ESP32 Stepper Motor Analyzer

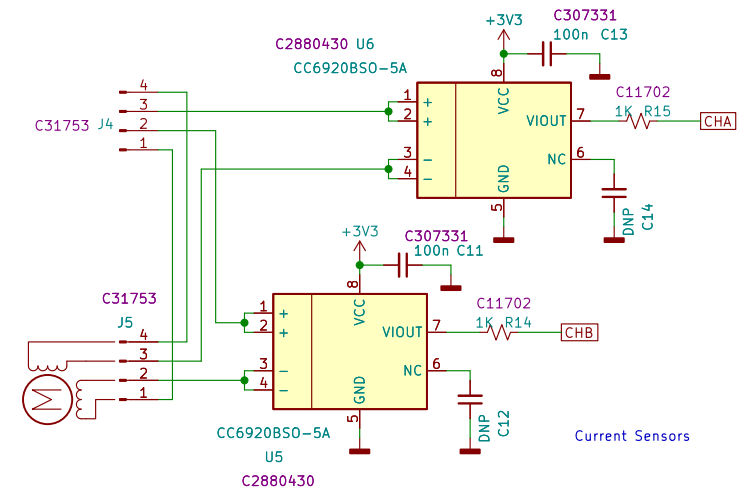
TODO: Add current protection resistor to U1 Pin 8 incase power jumper is missing or wrong position?
